ALIB Composite Ltd

Vannara, Mouchak, Kaliakoir, Gazipur
(24.036871N, 90.296459E)

17th February 2020

Bolt missing in connection

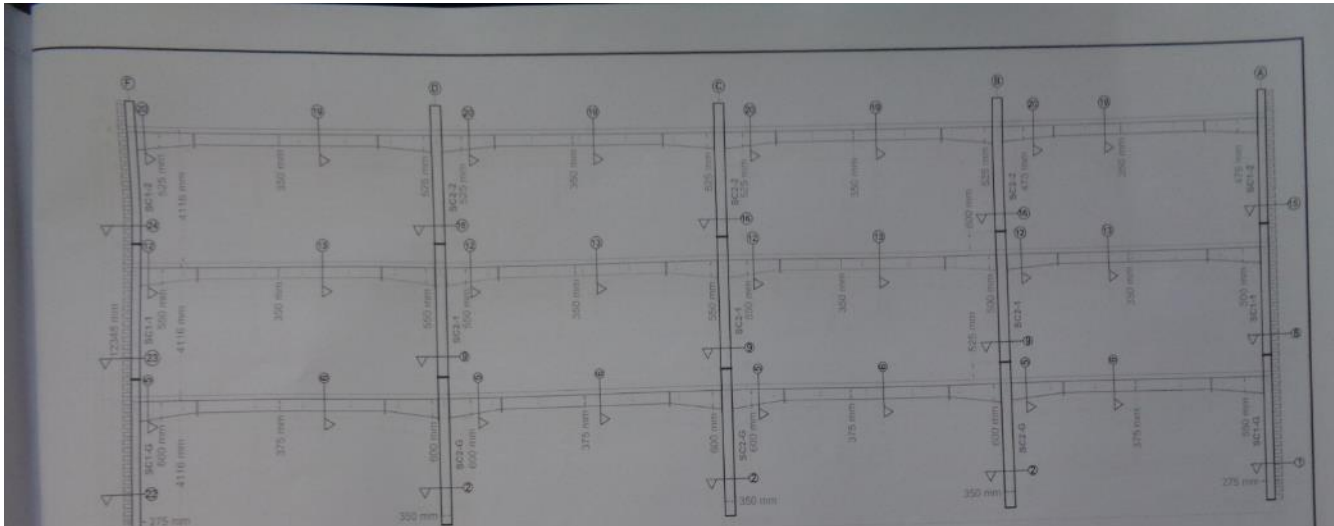
Bolt was found missing. Building engineer is required to reinstall the bolts.
